WATER DISTRIBUTION SYSTEM to serve TEXTRON AVIATION EAST CAMPUS B89 TRAINING FACILITY CITY OF WICHITA, KANSAS

Contractor: McCullough Excavation <i>2/17/2023</i>	Project Inspector: Larry Gann KEMILLER ENGINEERING PA 117 E. Lewis, Wichita, KS 67202 (316)264-0242
---	--

ASI #2 03.09.2023
 BID SET 11.22.2022
 TITLE SHEET

TEXTRON AVIATION
BUILDING B089 - TALENT AND TRAINING
 303 S Greenwich Rd, Wichita, KS 67207 - EAST CAMPUS B089

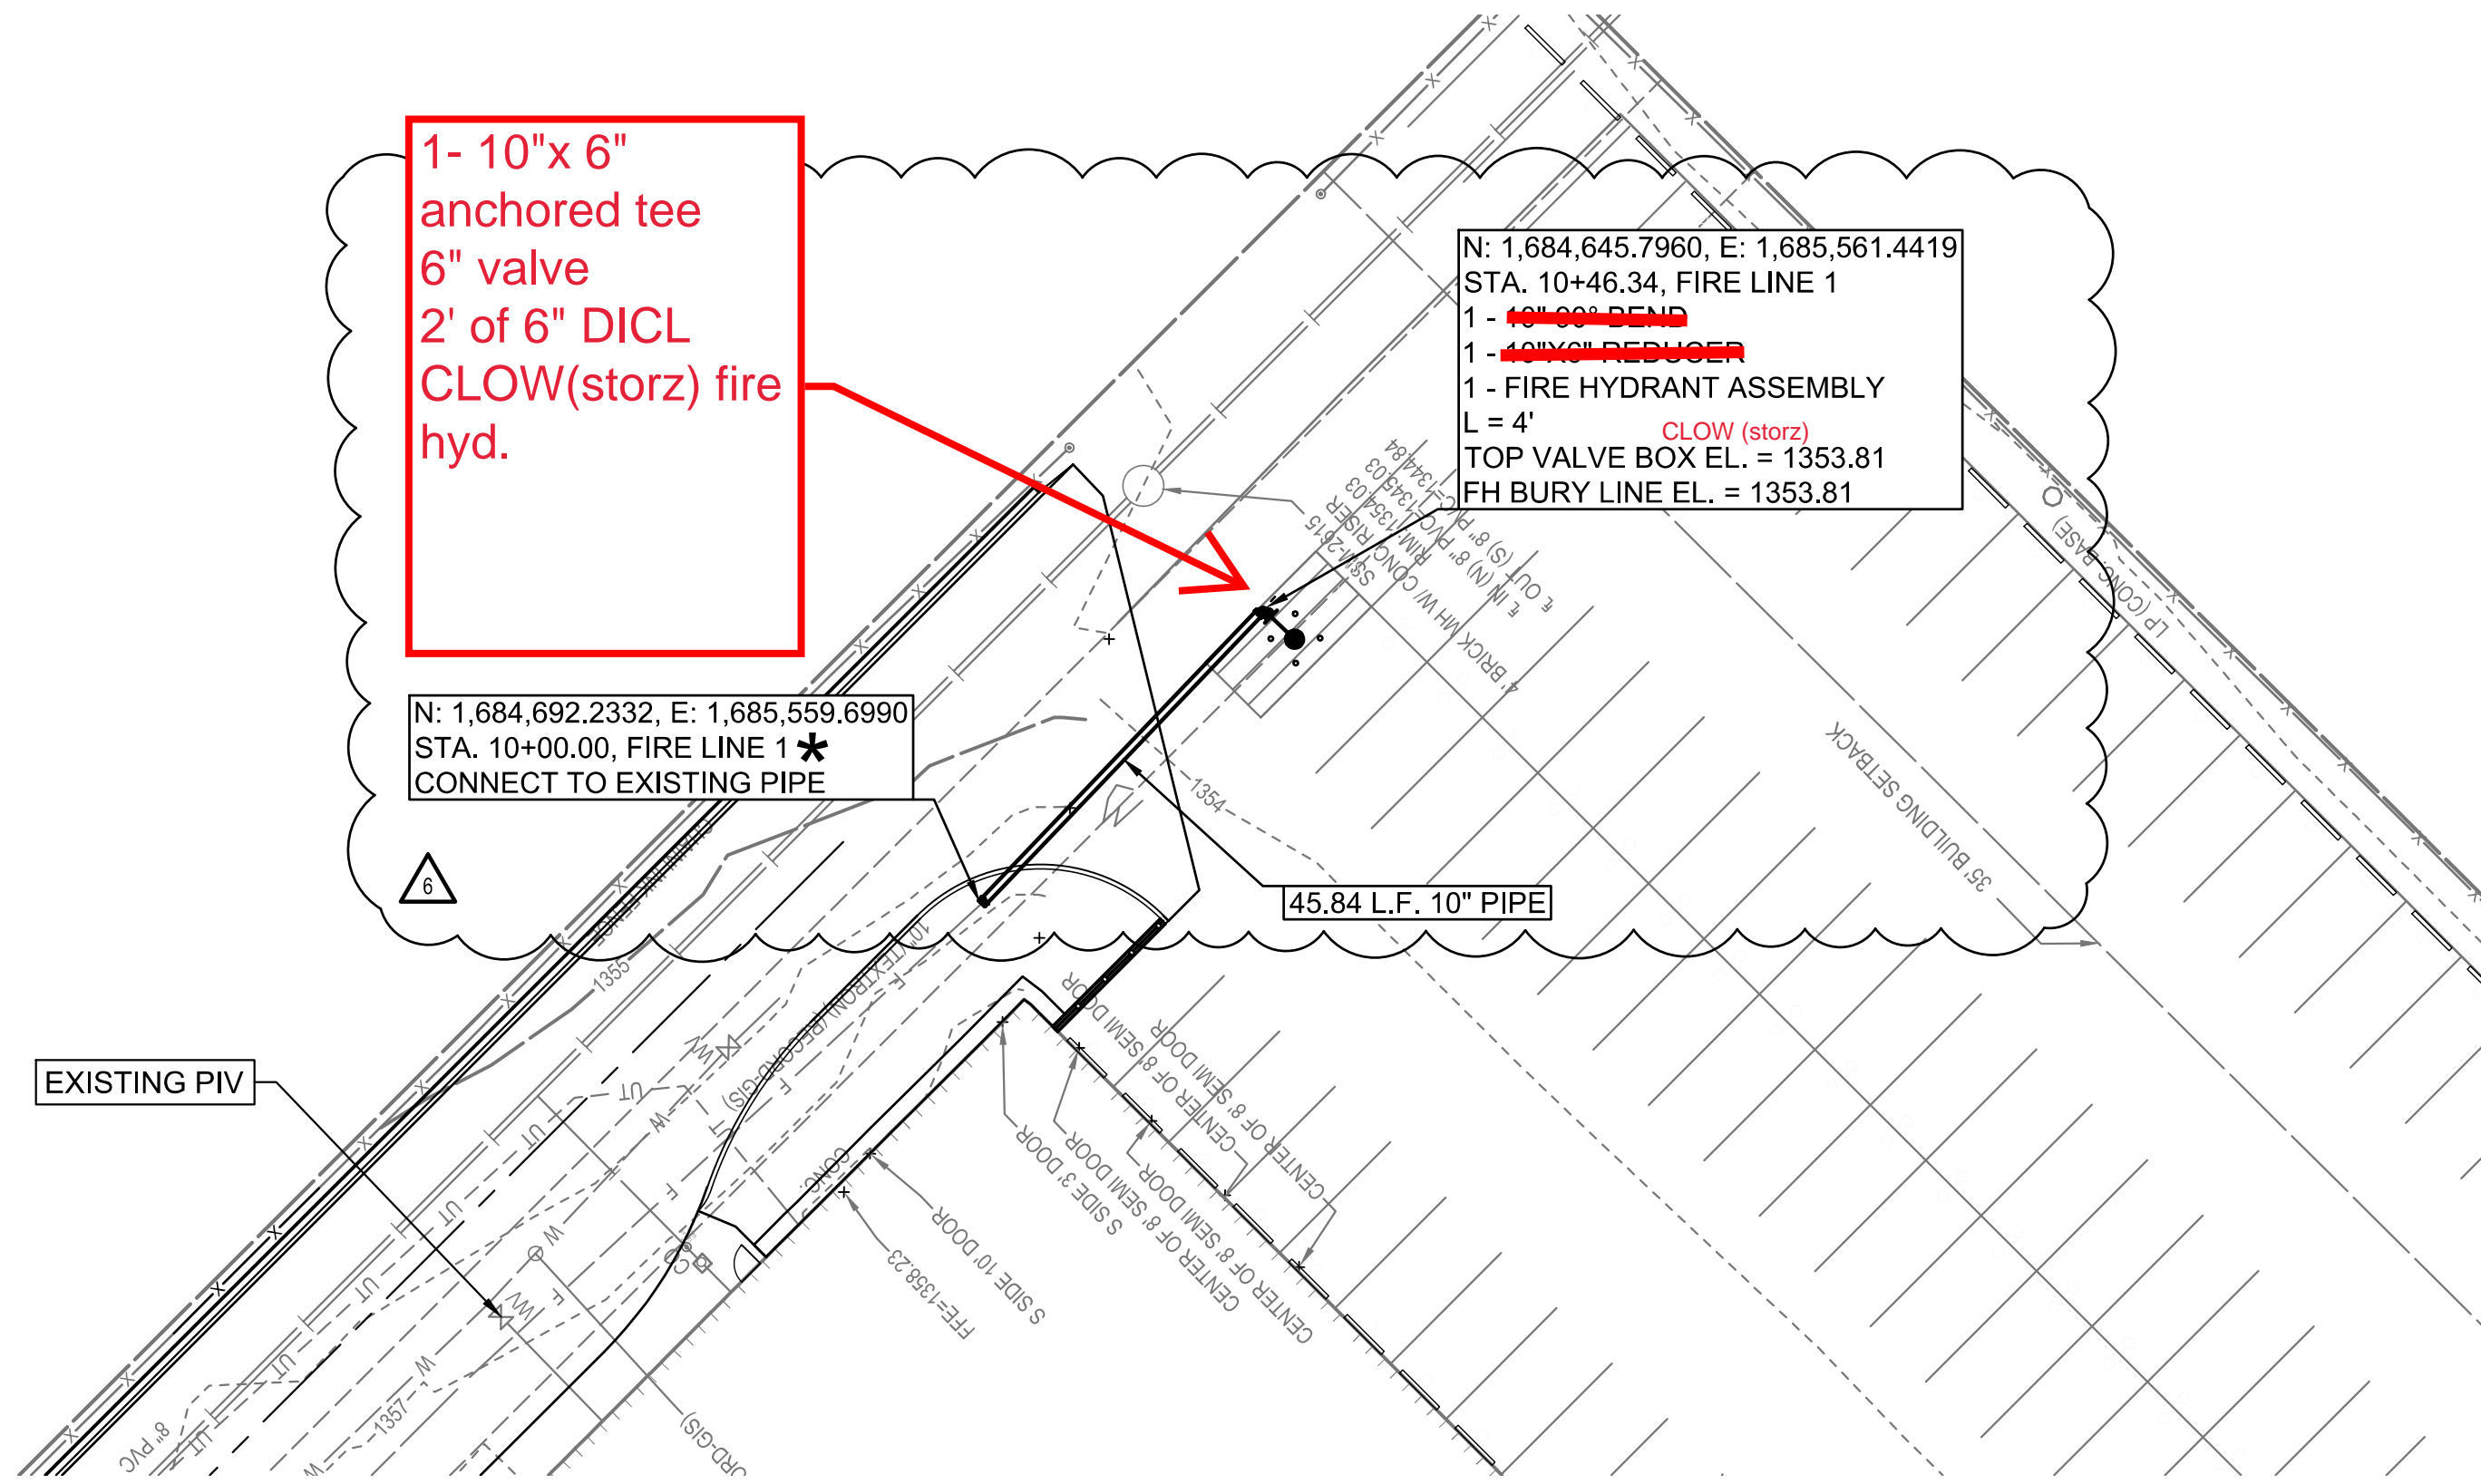
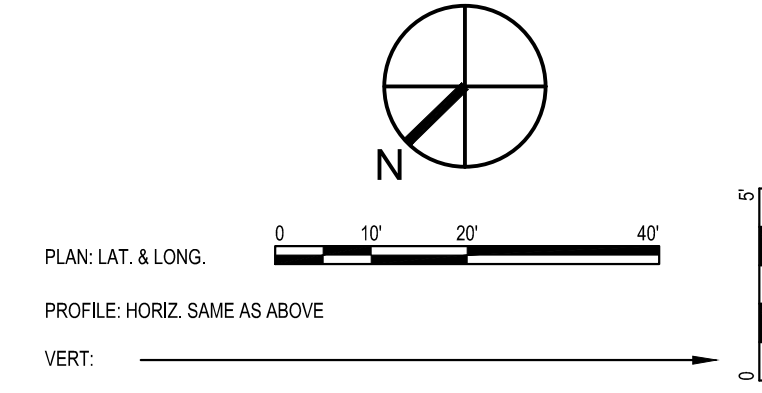
Mueller (storz) fire hyd.
 installed new hydrant 98.9' North of old fire location. From corner of building 49.8' West and 26.1' South to new fire hyd.

No tracer wire on existing line, none installed on new line.

REMOVED OLD HYD. & VALVE BOX CAPPED DICL ON VALVE

Sigma MJ Gland pack
 Sigma fittings
 Mueller (storz) fire hyd.
 American DICL pipe
 bury depth = 5' with 1' ext. = 6' depth

connect to 10" dia. pvc with long sleeve then 29" of 10" dia dicl pipe to the tee, then valve, then 24" of 6" dicl pipe to the fire hyd.

CU202

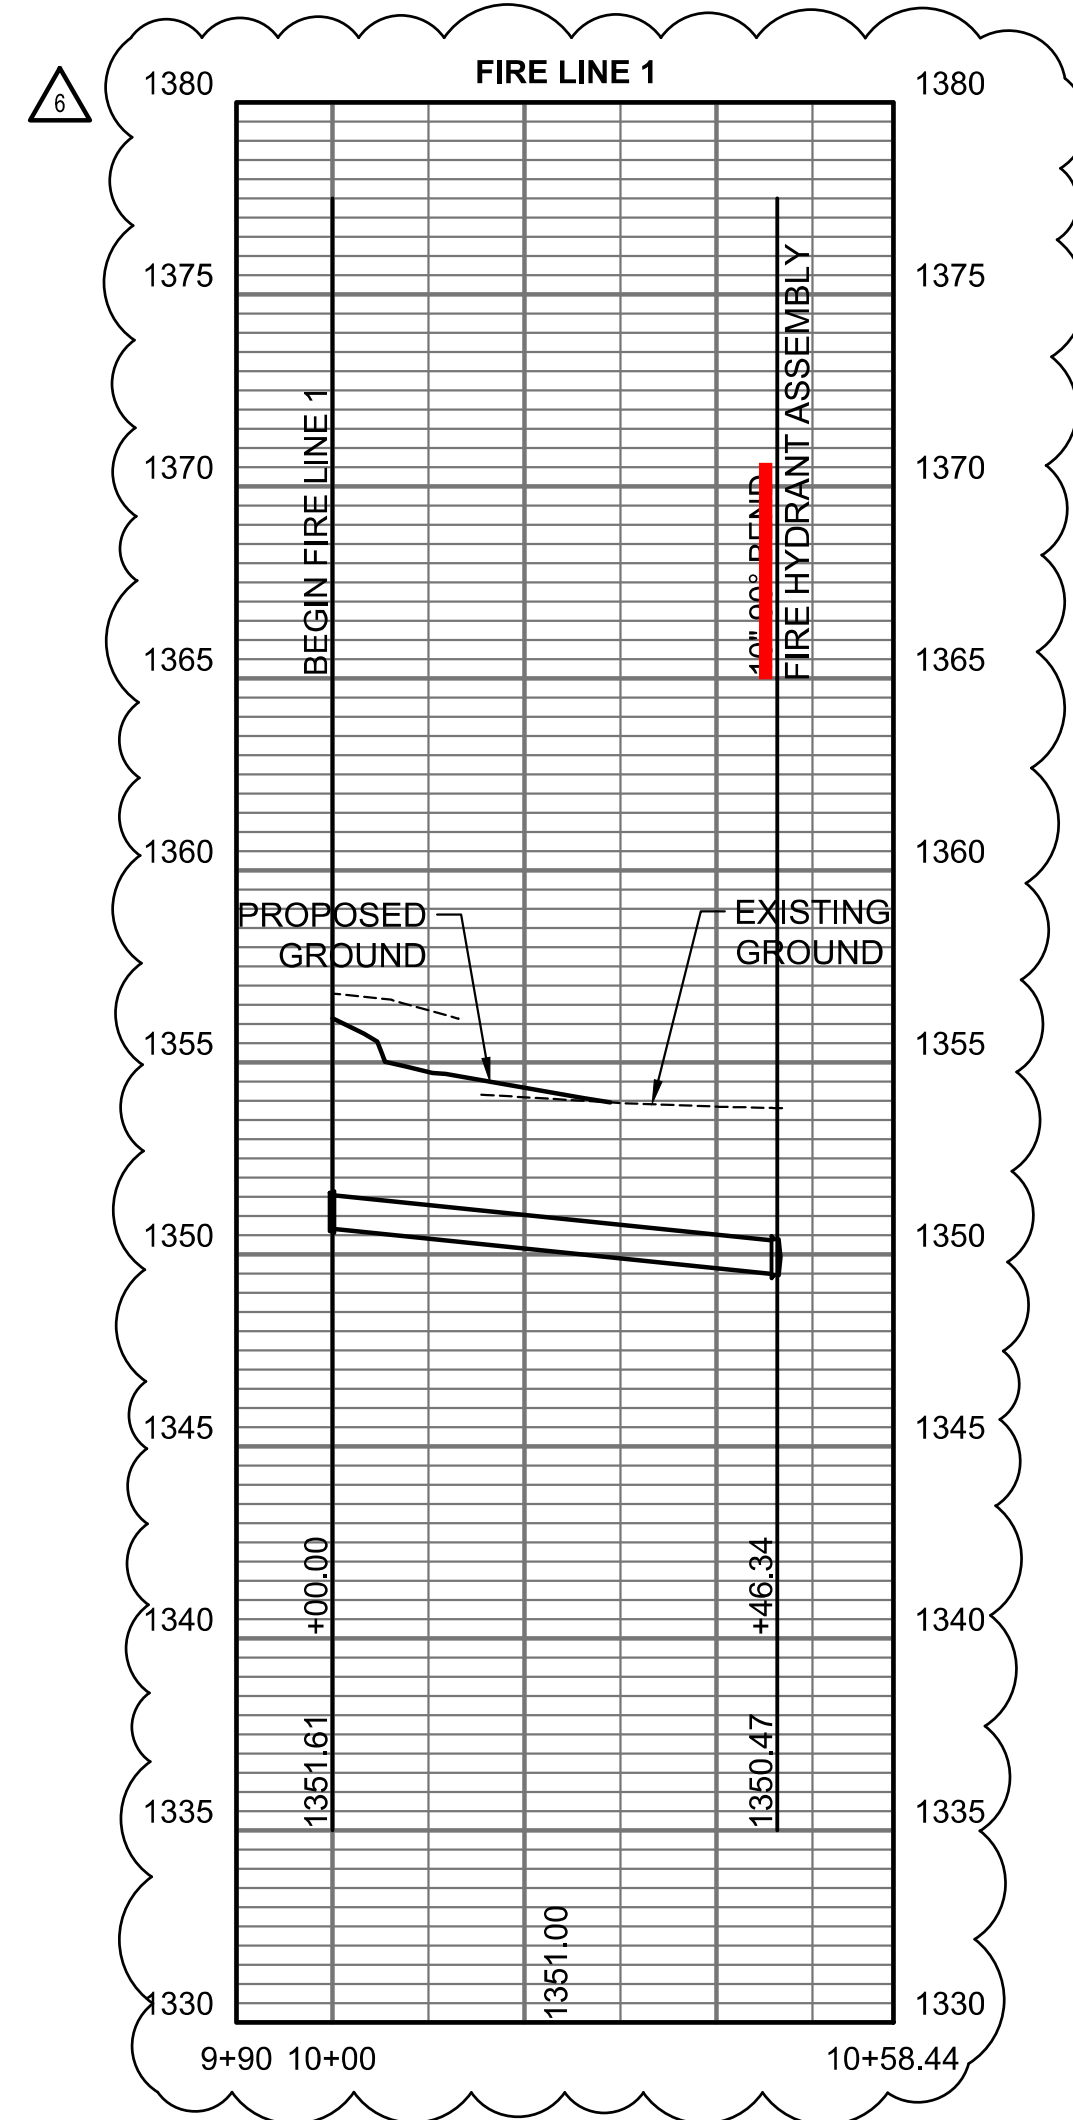
No tracer wire on existing line, none installed on new line.
